RE: Creekside Subdivision Application for Preliminary Plat Approval

TESTIMONY ON CREEKSIDE DEVELOPMENT

The following pictures provide you with some idea of the nature of the stream and environment that we are concerned.

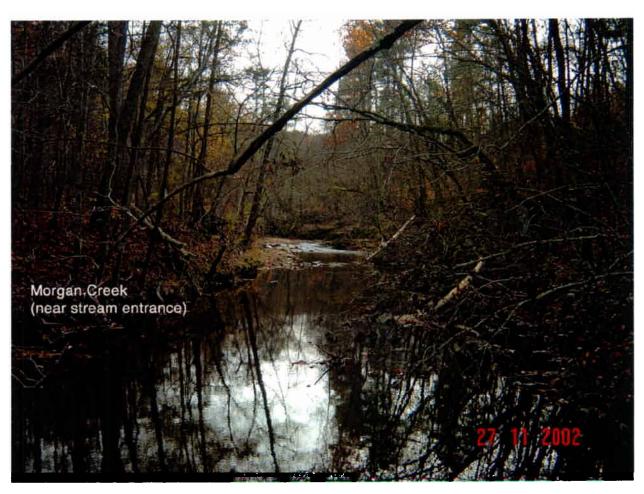
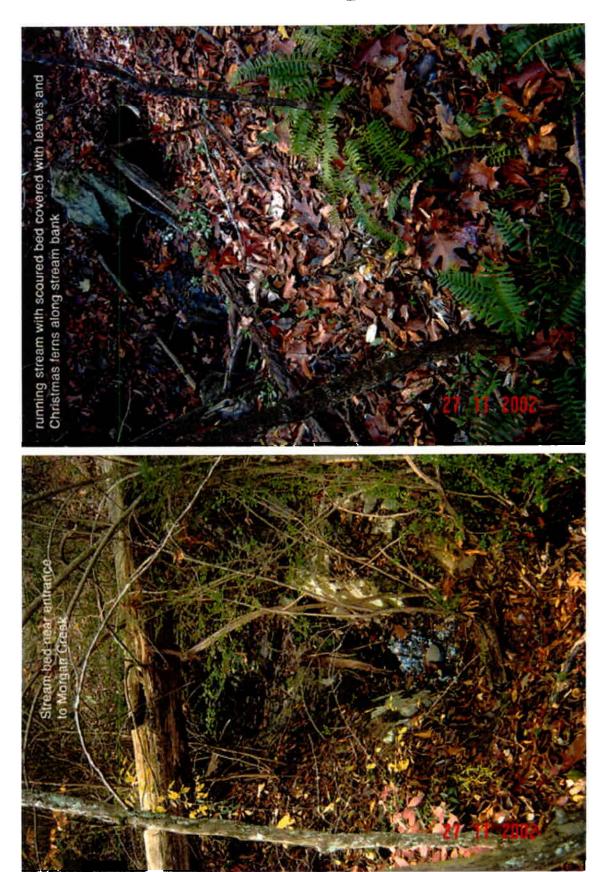
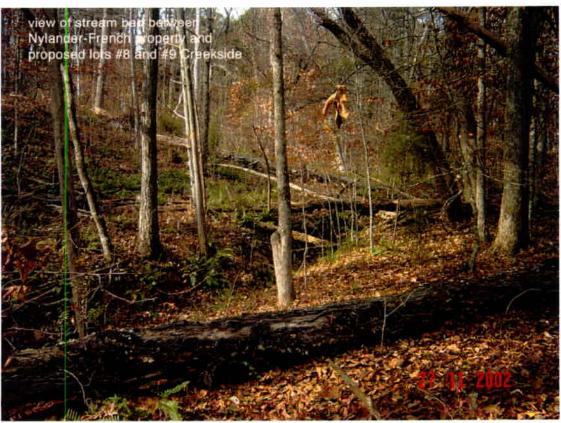
- 1) the recognition of the resource conservation district, which should include this stream and protection of this area from invasive species, such as bamboo grass, that may result from disturbance to indigenous plants.
- 2) the potential impact of the storm water runoff pipes proposed between Creekside lots 8 & 9 and north of lot 11 that will dump surface water and contaminants into the stream, and
- 3) the development of a path that has been planned to run between proposed lots #8, 9, 10, and 11 and the-Blyth and French-Nylander properties, resulting in the potential infestation of non-indigenous species.

Therefore, we, respectfully, request that the planning department engineers and planners pay close attention to the RCD and other areas bordering this proposed development with the goal of preservation of this area to the maximum extent possible and consistent with the proposed new land use ordinance (draft 4).
